KD8 (-B) Modular Door Station(Main Module)

Release Note (2025-08-25)

Device Model	Firmware Version
DS-KD8003-IME1(B), DS-KD8003-IME1(B)/Surface DS-KD8003-IME1(B)/Flush, DS-KD8003-IME1(B)/S DS-KD8003-IME1(B)/NS, DS-KD8003Y-IME2 DS-KD8003Y-IME2/S, DS-KD8003Y-IME2/NS DS-KIS602(B), DS-KIS702Y	V3.7.1_build250819

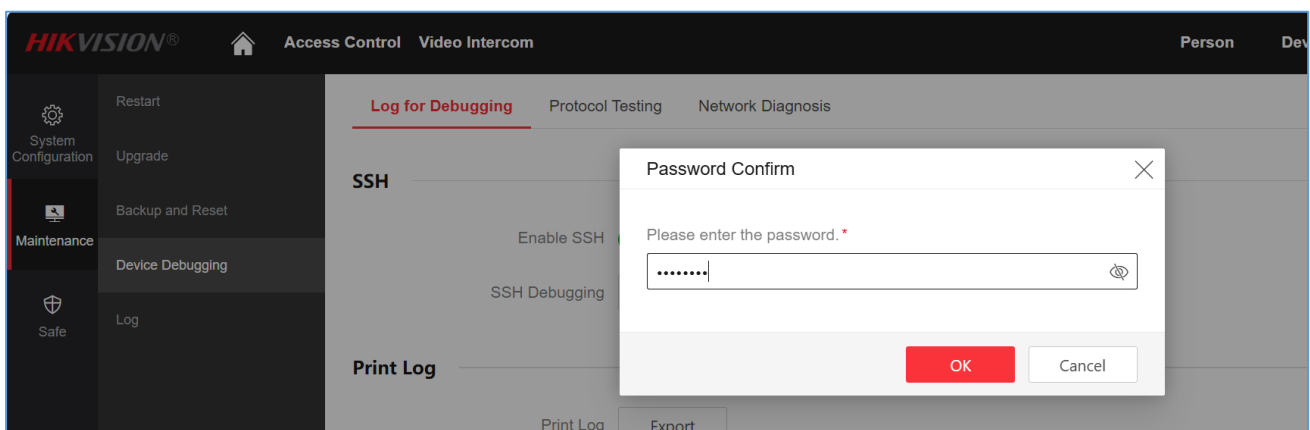
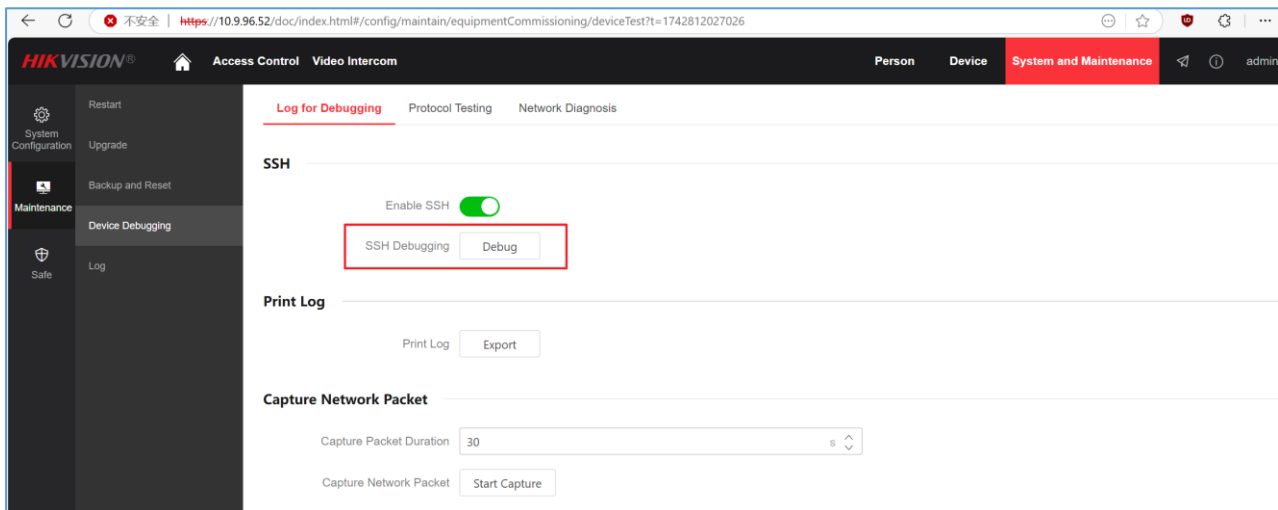
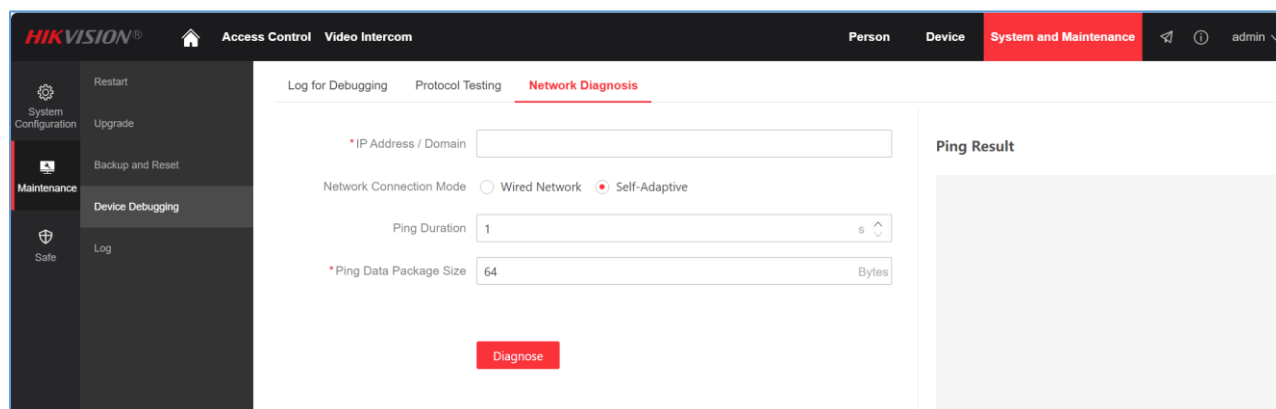
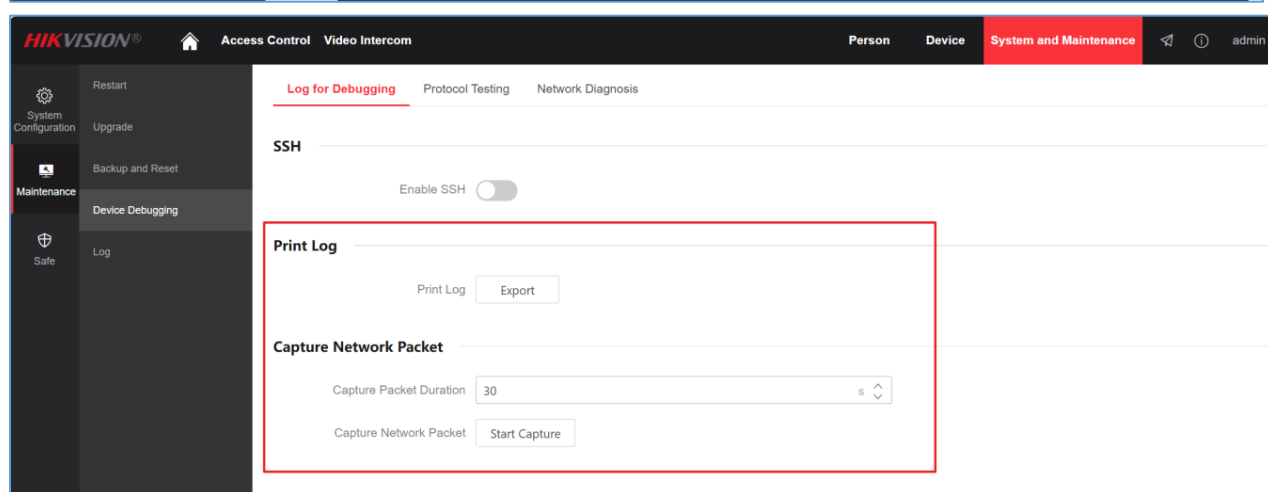
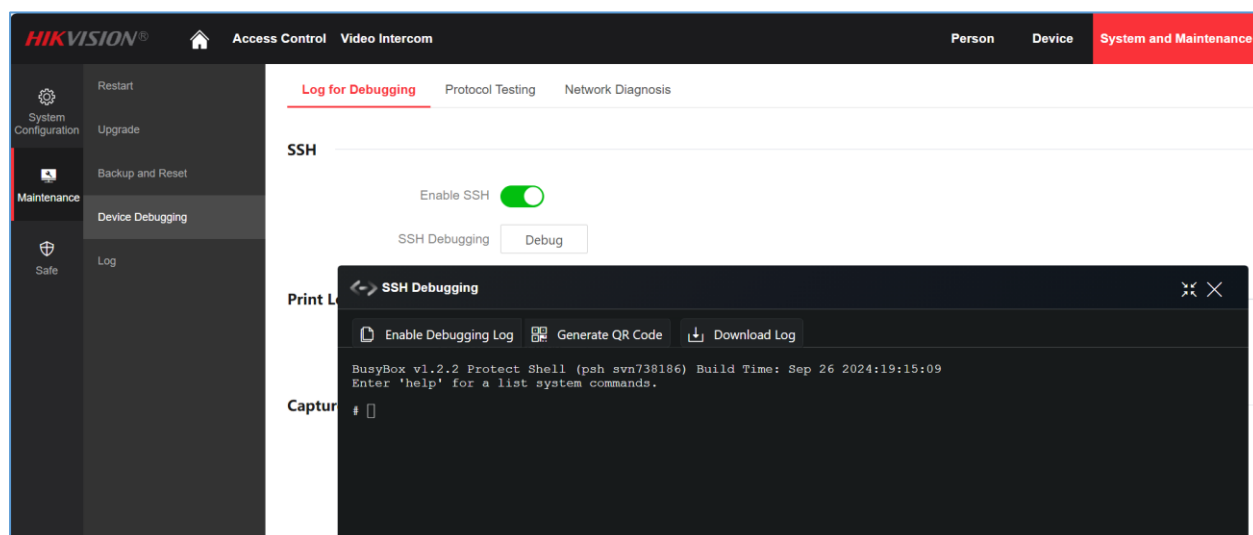
7. Support operation log search(max 1,000), including unlock records, call elevator records, tamper alarm, login in/out records, etc.

8. Support web SSH, key logs export, ping tools, capture network packet on the webpage for easier technical diagnose

Note: web SSH function is only available in HTTPS protocol, please login device webpage with https. For example <https://device ip address/>

- Support protocol testing, security audit log uploading, https certificate import for easier integration and higher security.

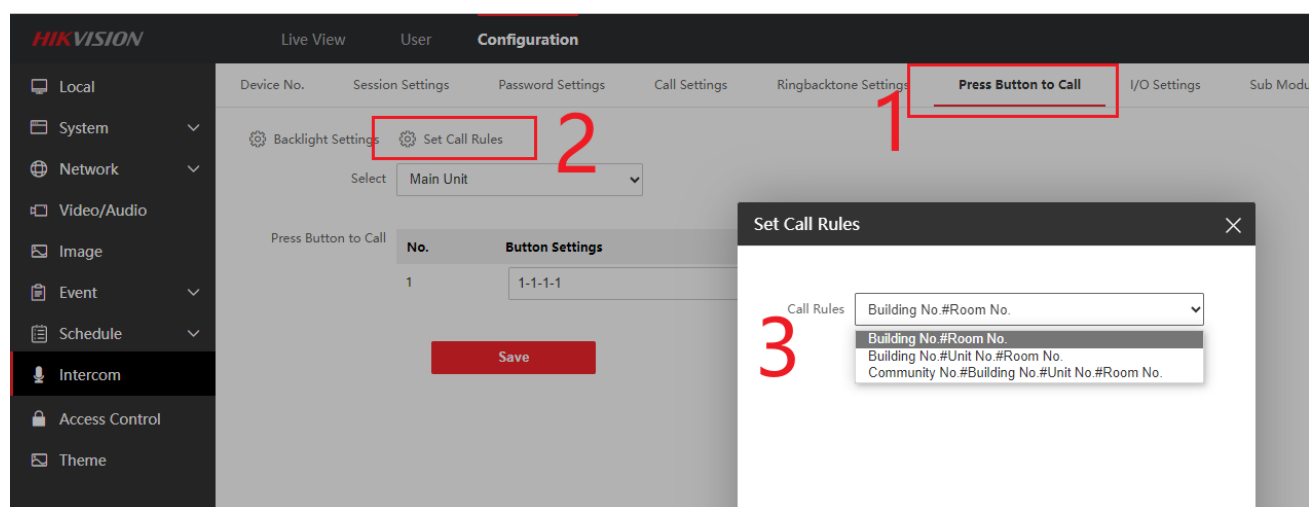
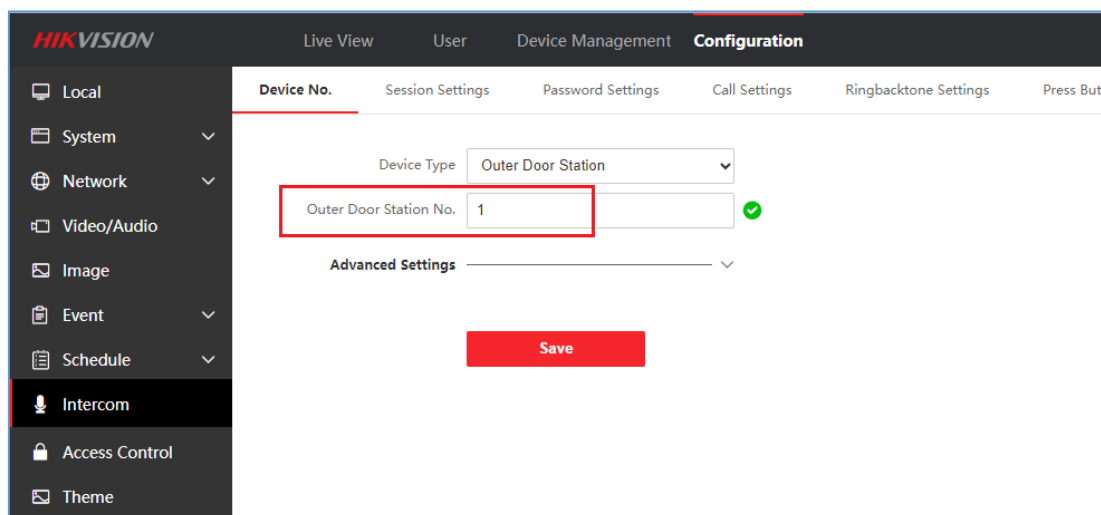
2. Add calling mode for outer door station. It supports 3 modes to call indoor station, and there's no need to input full 4 digits room number. For example 1#1 is calling 1-1-1-1 by default.

- 1) Building No.# Room No.
- 2) Building No.# Unit No.# Room No.
- 3) Community No.# Building No.# Unit No.

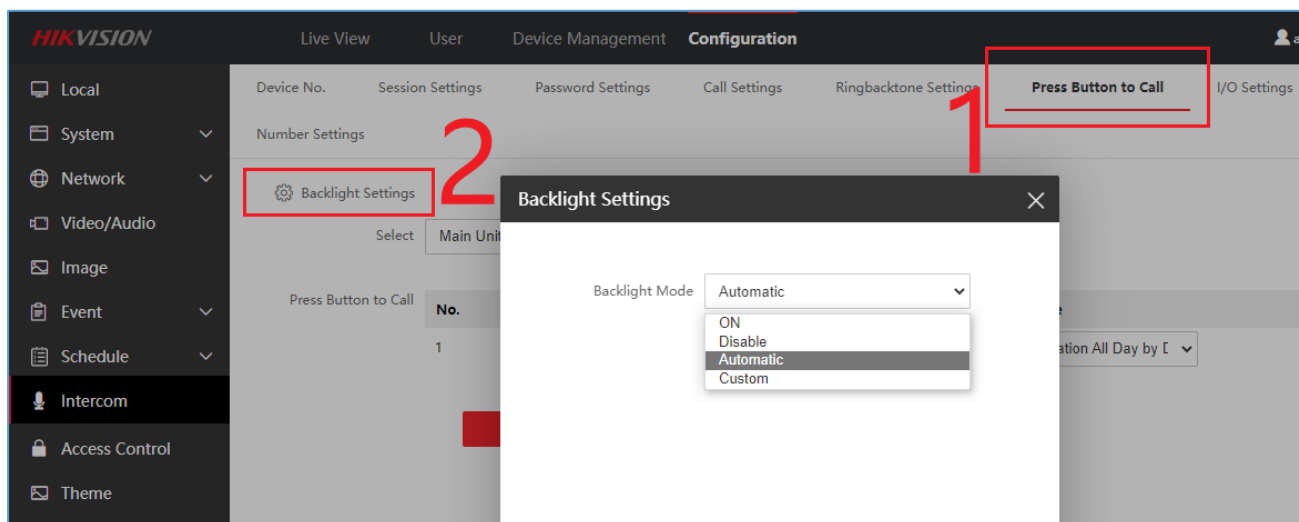
1. Add sub module **backlight** control: 4 modes (close, open, auto and custom), support DS-KD-KK, DS-KD-KP, DS-KD-INFO modules

Close: always OFF

Open: always ON

Auto: ON and OFF according to the ambient light brightness

Custom: ON and OFF according to configured time schedule

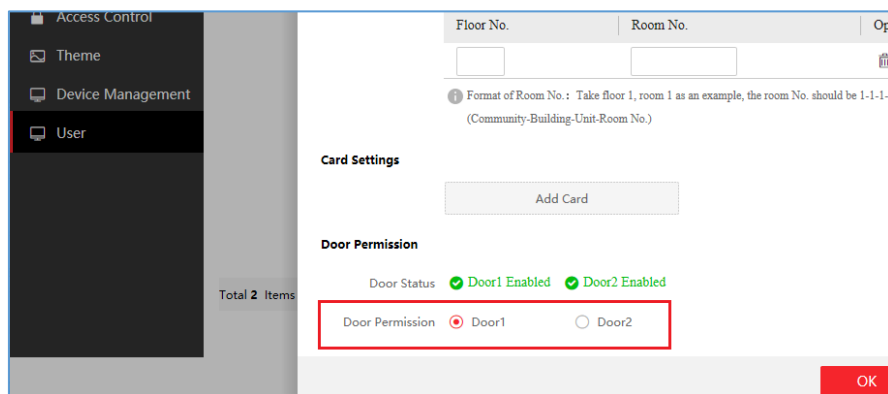
4. Support capture device image through ISAPI protocol.

/ISAPI/Streaming/channels/1/picture?snapShotImageType=JPEG&videoResolutionWidth=1280&videoResolutionHeight=720&imageQuality=better

snapShotImageType: picture format, only support JPEG now

videoResolutionWidth: videoResolutionHeight: picture resolution, if not use this parameter, by default it's 704*576. Supported resolution: 1280*720, 704*576, 704*480, 352*288, 352*240, 176*144, 176*120

imageQuality: support best, better, normal, general

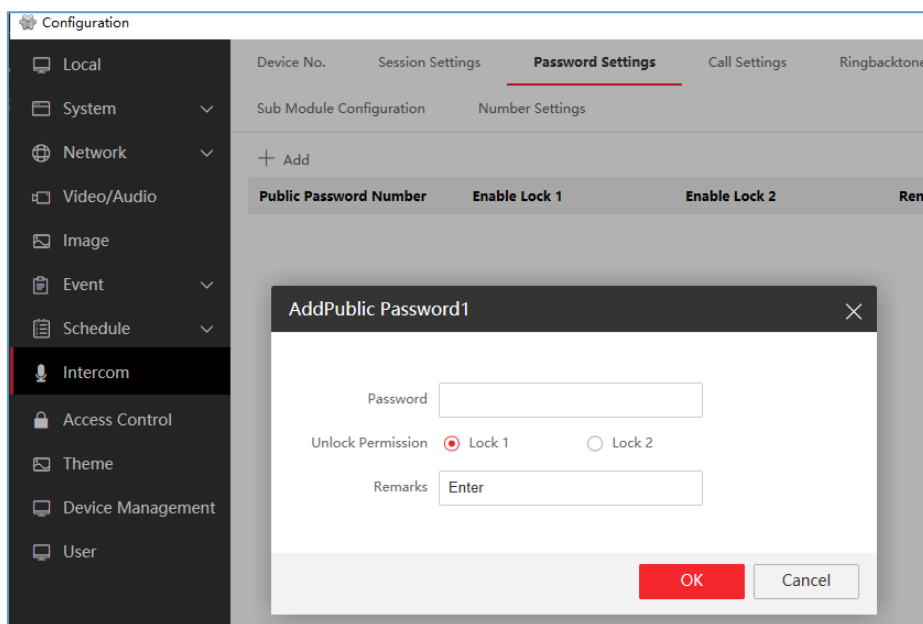
1. Support swipe card to open lock2: when adding new person, you can link to lock 1 or lock 2, and after swipe card, the related lock will be open.

Note: before the lock was linked to card module DIP switch, now we cancelled this logic so that we can open different lock with same card module.
